City of Mobile
Request for Proposals
Addendum 1
RFP 5704

CITY OF MOBILE, ALABAMA CRUISE TERMINAL
SEAPORT BOARDING BRIDGE DESIGN, CONSTRUCTION, DELIVERY

Add. Exhibit A Cruise Terminal Main Building Operating Doors

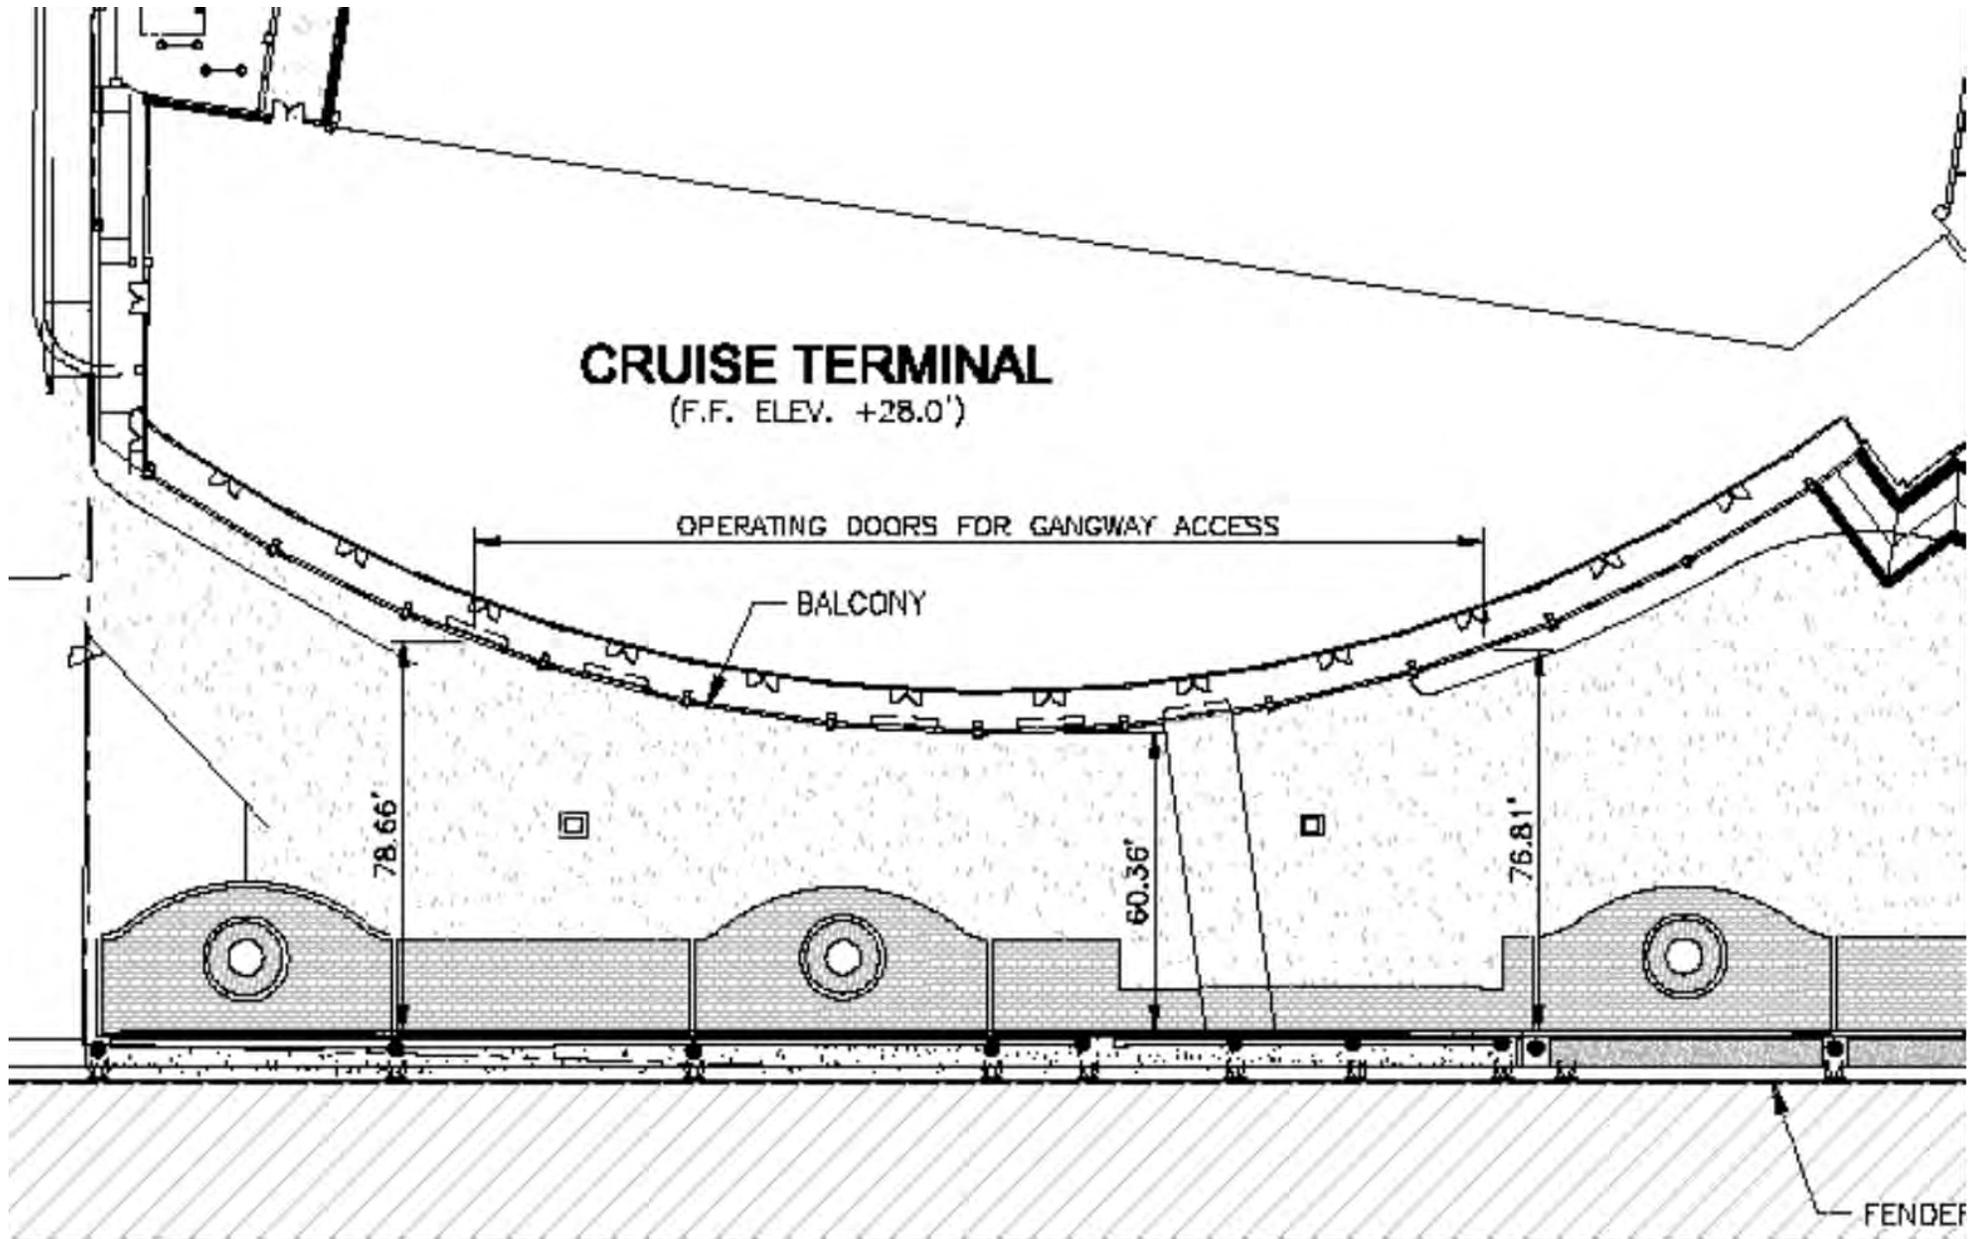
- b. Add to Paragraph 2.4.2: **Add. Exhibit A** *is provided to show the operating doors at the curved section of the Terminal that the SPBB must accommodate (identified on the drawing as "OPERATING DOORS FOR GANGWAY ACCESS."). The SPBB must additionally accommodate all doors on the fixed gangway parallel to the pier face at the North end of the facility.*

9. *Could you please indicate which terminal doors and fixed bridge doors should be served?*

See Paragraph 2.b and Add. Exhibit A earlier in this Addendum.
